APICAL INDUSTRIES, INC.
dba DART AEROSPACE

ENGINEERING CHANGE NOTICE NO. 05397

DWG NO. 647.7700

DWG TITLE: STRUT ASSY

SHEET 2, ZONE D4 IS:

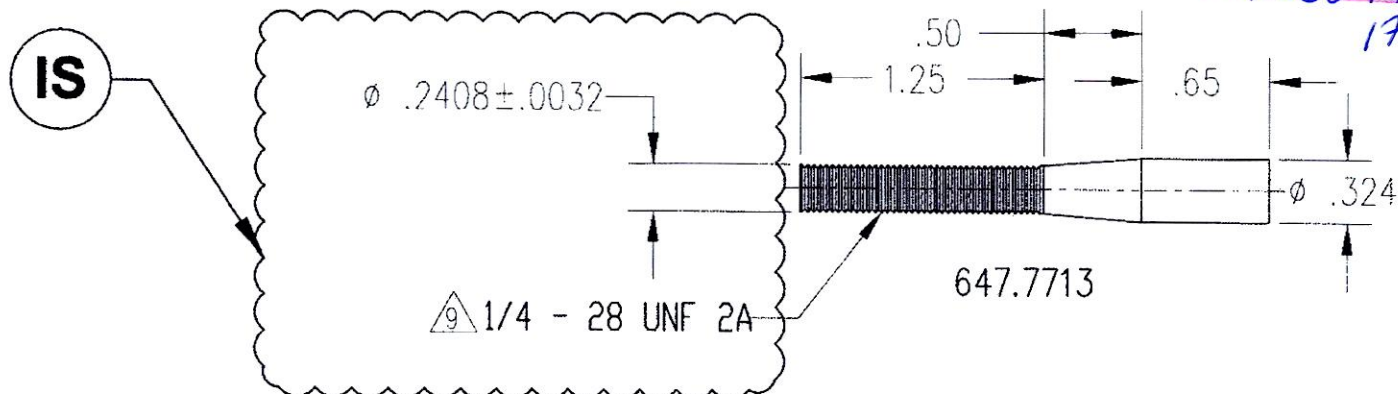
REASON: REVISED DIMENSION

ACTION LIST:
1.

STRUT ASSY

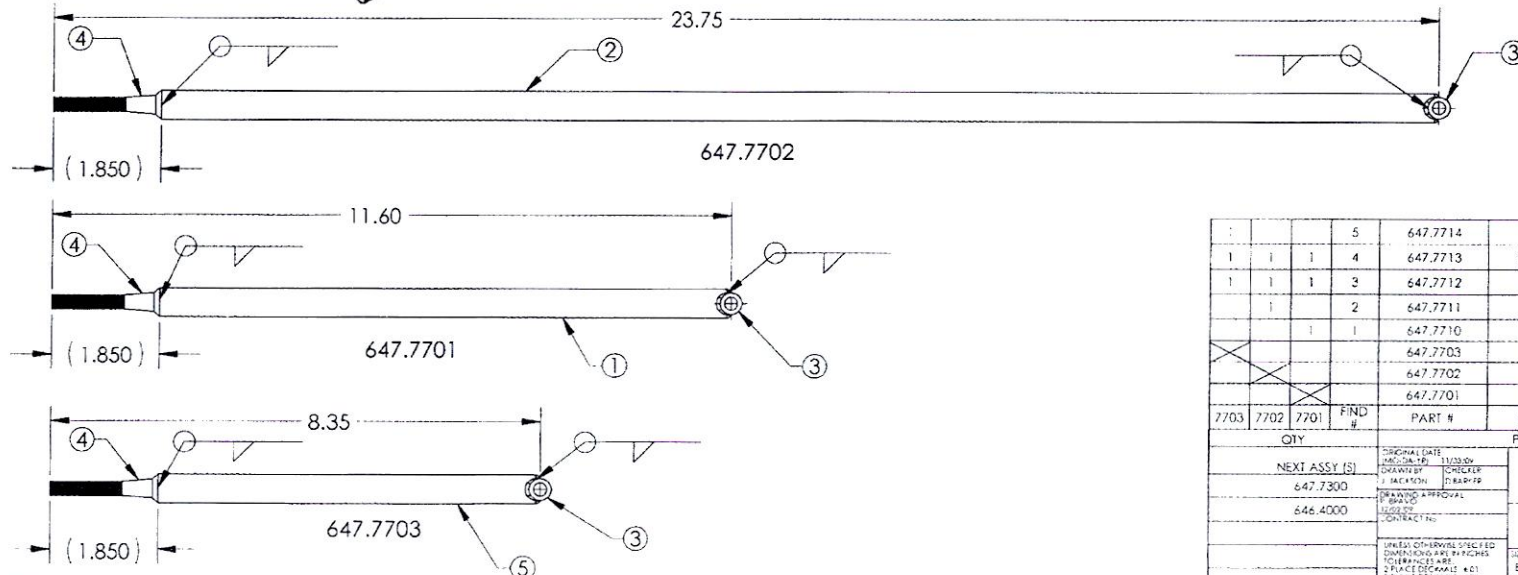
REASON: REVISED FINISH CALLOUT AS PER ECR 15-209

SHEET 1, NOTES IS:

- 1 MATERIAL: 4130 STEEL PER AMS-T-6736, .50" OD, .083" WALL THK.
- 2 MATERIAL: 4130 STEEL PER AMS-T-6736, .375" OD, .075" WALL THK.
- 3 MATERIAL: 4130 STEEL PER AMS-T-6736, .324" OD.
- 4 FINISH: PRIME IAW MIL-P-2337J TYPE I CLASS N; 1-2 MIL MAX
5. DEBURR AND BREAK ALL SHARP EDGES
6. IDENTIFY IAW MPP-120.
- 7 WELD IAW MIL-STD-2219. TIG WELD WITH FILLER ROD
- 8 FINISH: CAD PLATE IAW QQ-P-416F CLASS I TYPE II
- 9 MASK THREAD PRIOR TO FINISH

- 1 MATERIAL: 4130 STEEL PER AMS-T-6736, .50" OD, .083" WALL THK.
- 2 MATERIAL: 4130 STEEL PER AMS-T-6736, .375" OD, .075" WALL THK.
- 3 MATERIAL: 4130 STEEL PER AMS-T-6736, .324" OD.
- 4 FINISH: PRIME IAW MIL-P-2337J TYPE I CLASS N; 1-2 MIL MAX
- 5 DEBURR AND BREAK ALL SHARP EDGES
- 6 IDENTIFY IAW MPP-120.
- 7 WELD IAW MIL-STD-2219, TIG WELD WITH FILLER ROD
- 8 FINISH: CAD PLATE IAW MIL-C-5541 CLASS 1A
- 9 MASK THREAD PRIOR TO FINISH
